Staff Summary Report

Development Review Commission Date: 06/12/12

SUBJECT: Hold a public meeting for a Development Plan Review for CAMPUS CRUSADE FOR CHRIST, located at 205 E. 15th Street.

DPR12070 – Development Plan Review including site plan, building elevations, and landscape plan.

SITE PLAN
SCALE: 1/16" = 1'-0"

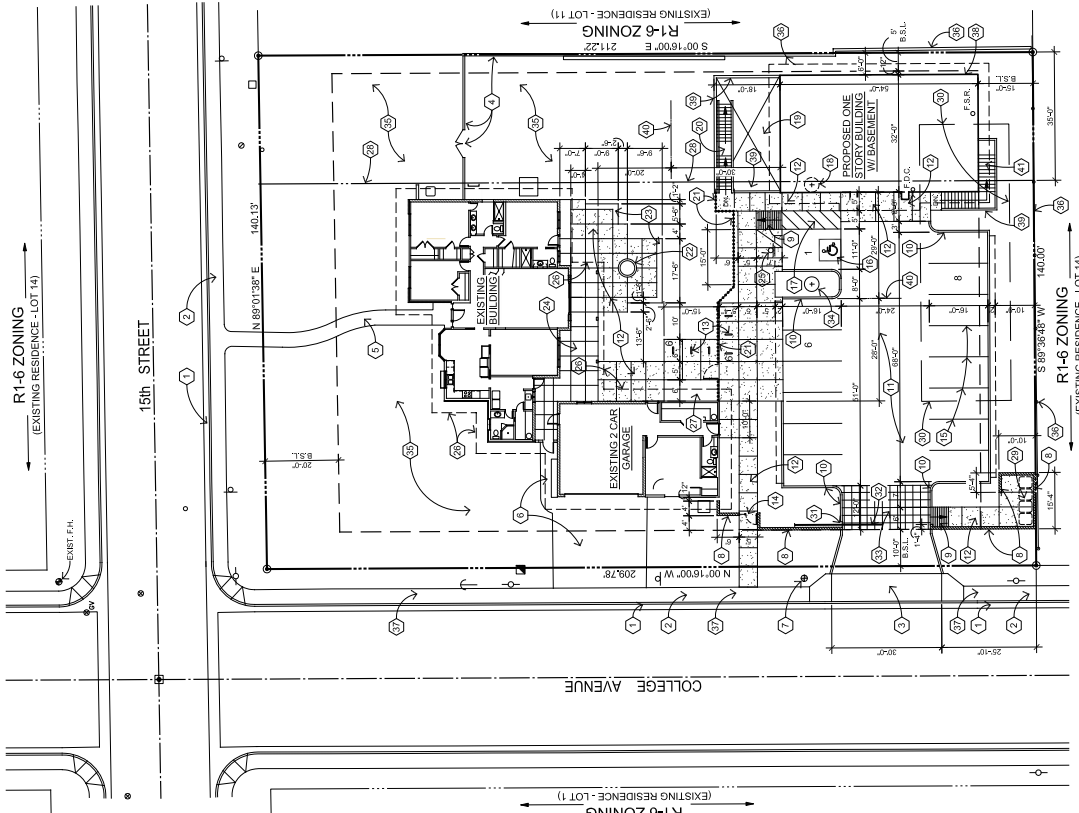
The new building would be tucked back in the farthest south east corner of the lot, minimizing visibility from either street. The parking area is gated and heavily landscaped along College Avenue. The property to the south is a vacant Tempe Water Utilities Department site, adjacent to the railroad tracks. New landscape is proposed along the south property line. A six foot landscape buffer is required along the east side, adjacent to the residential lot. The heavily landscaped front yard and yard wall will screen most of the narrow side of the building from the 15th Street view, except possibly the top portion of the 16' peak of the single story roof. The lower basement level opens into a small courtyard on the north elevation, facing the house.

3. Screen all mechanical equipment either on-roof or in yard with walls at least the height of the equipment being enclosed. Verify height of equipment and mounting base to ensure that wall height is adequate to fully screen the equipment. Locate electrical service entrance sections inside the service yard.

4. Provide gates of steel vertical picket, steel mesh, steel panel or similar construction. Where a gate has a screen function and is completely opaque, provide vision portals for visual surveillance. Provide gates of height that match that of the adjacent enclosure walls. Review gate hardware with Building Safety and Fire staff and design gate to resolve lock and emergency ingress/egress features that may be required.

5. Provide upgraded paving at driveway consisting of unit paving. Extend this paving in the driveway from the right-of-way line to 20'-0" on site and from curb to curb at the drive edges. From sidewalk to right-of-way line, extend concrete paving to match sidewalk.

8. Preserve identified existing mature Pecan Tree in place as indicated on plans.
9. Parking gate must remain open during hours when meetings are being held.

1st FLOOR - FLOOR PLAN
 SCALE: 3/16" = 1'-0"
 * INDICATES TEMPERED GLASS

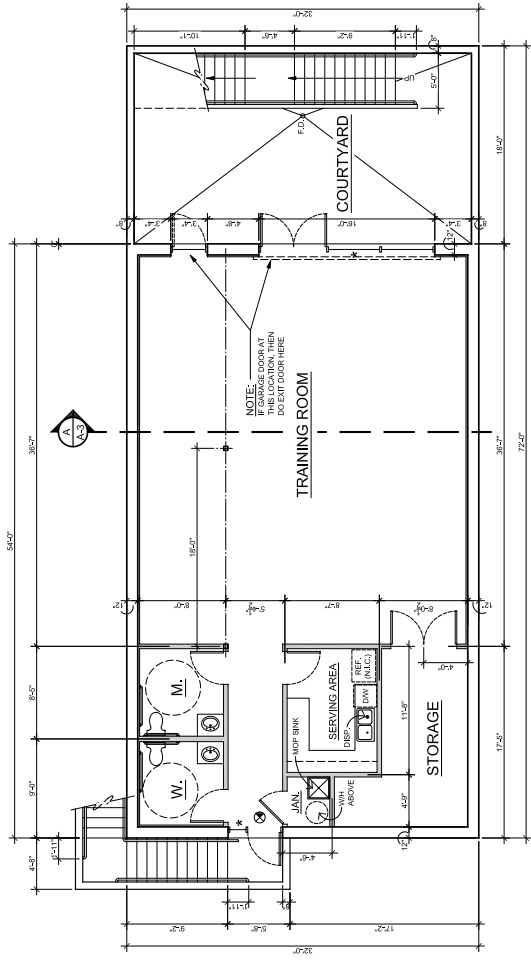
12. Exit Security: Provide visual surveillance by means of fire-rated glazing assemblies from stairs into adjacent circulation spaces.

LANDSCAPE PLAN
SCALE: 1" = 40'

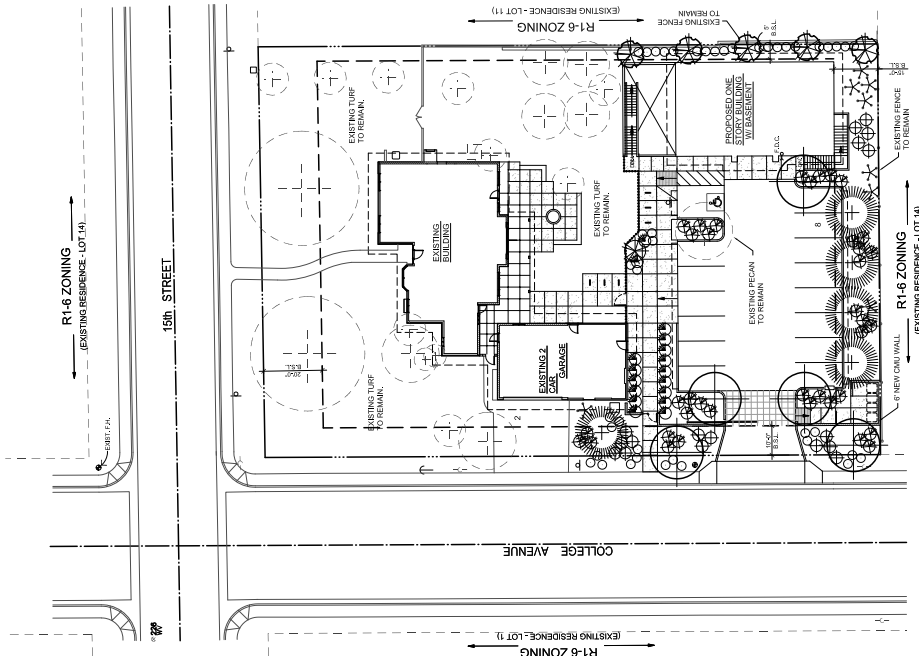
The landscape includes existing flood irrigated mature landscape along 15th Street and within the back yard of the residence. New landscape is provided for the new building site, with Southern Live Oak, Lantana and Hesperaloe along College Avenue, Mondel Pine, Ermophila Bush and Red Bird of Paradise along the south perimeter, and Texas Mountain Laurel along the east perimeter. There are two existing mature Pecan trees in the parking and building site area, the design keeps one of these trees for additional shade on the parking area and new building. The integration of existing and new landscape will improve the southern portion of the site. The new landscape will be on xeriscape irrigation, reducing water consumption for this portion of the site, while retaining the mature irrigated landscape along the residential street front. The diverse plant palette blends with the existing neighborhood character.

21. The plant palette is approved as proposed and specified on the landscape plan. Any additions or modifications may be submitted for review during building plan check process.

22. Irrigation notes:
 - a. Provide pipe distribution system of buried rigid (polyvinylchloride), not flexible (polyethylene). Use of schedule 40 PVC mainline and class 315 PVC ½" feeder line is acceptable. Class 200 PVC feeder line may be used for sizes greater than ½". Provide details of water distribution system.

23. Include requirement to de-compact soil in planting areas on site and in public right of way and remove construction debris from planting areas prior to landscape installation.

24. Top dress planting areas with a rock or decomposed granite application. Provide rock or decomposed granite of 2" uniform thickness. Provide pre-emergence weed control application and do not underlay rock or decomposed granite application with plastic.

25. Trees shall be planted a minimum of 12'-0" from any existing or proposed public water or sewer lines located on-site. Trees near the main water or sewer lines located within the right of way shall be planted at least 20'-0" away. Final approval subject to determination by the Public Works, Water Utilities Division.

WEST ELEVATION
 SCALE: 3/16" = 1'-0"

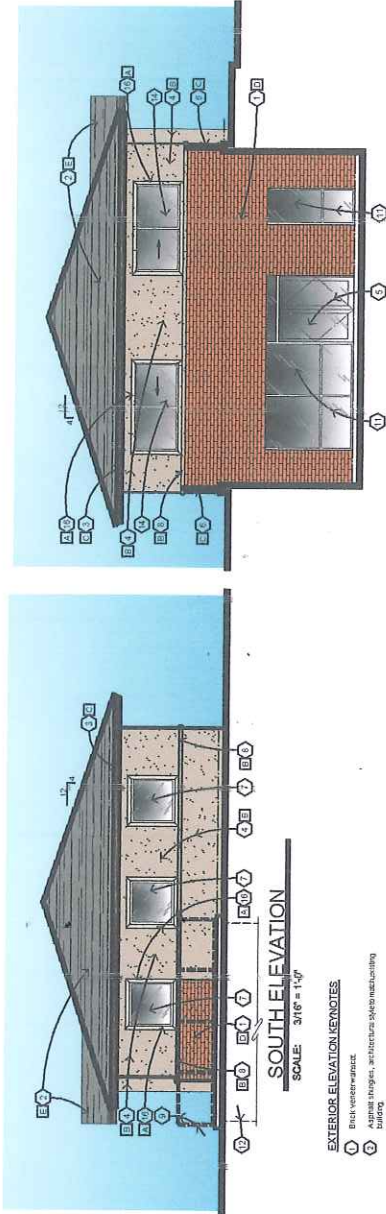
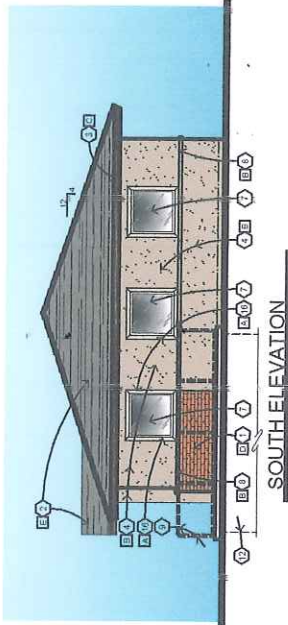
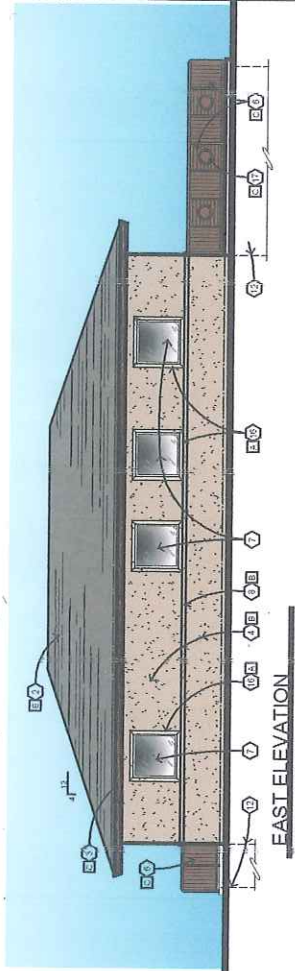
The new building is designed as a single-story structure to minimize visual impact to surrounding residents and to remain in keeping with the residential character of the property. To accommodate the need for meeting space, a basement level is being built below the ground. The new building is designed to reflect the colors and materials of the existing residence on site. Brick veneer wainscot wraps the building on three sides, painted stucco system is the primary building material, trim is wood, all painted to match the existing building, roof is architectural shingles to match the residence on site.

13. The materials and colors are approved as presented:
 - Roof – Architectural asphalt shingles O.C. Oakridge Driftwood, to match existing building
 - Main building – EIFS with painted stucco Sherwin Williams SW2805 Renwick (beige)
 - Wainscot – Brick veneer to match existing residence
 - Windows, Doors & Wrought Iron Fence – Painted Sherwin Williams SW2837 Aurora Brown
 - Trim and Eaves – Painted Sherwin Williams SW6126 Navajo White
 - Windows – Fixed insulated glass in aluminum frame

Provide main colors and materials with a light reflectance value of 75 percent or less. Specific colors and materials exhibited on the materials sample board are approved by planning staff. Additions or modifications may be submitted for review during building plan check process.

14. Provide secure roof access from the interior of the building. Do not expose roof access to public view.
15. Conceal roof drainage system within the interior of the building.
16. Incorporate lighting, address signs, and incidental equipment attachments (alarm klaxons, security cameras, etc.) where exposed into the design of the building elevations. Exposed conduit, piping, or related materials is not permitted.
17. Locate the electrical service entrance section (S.E.S.) inside the building or inside a secure yard that is concealed from public view.
18. Upper/lower divided glazing panels in exterior windows at grade level, where lower glass panes are part of a divided pane glass curtain-wall system, shall be permitted only if laminated glazing at these locations is provided.
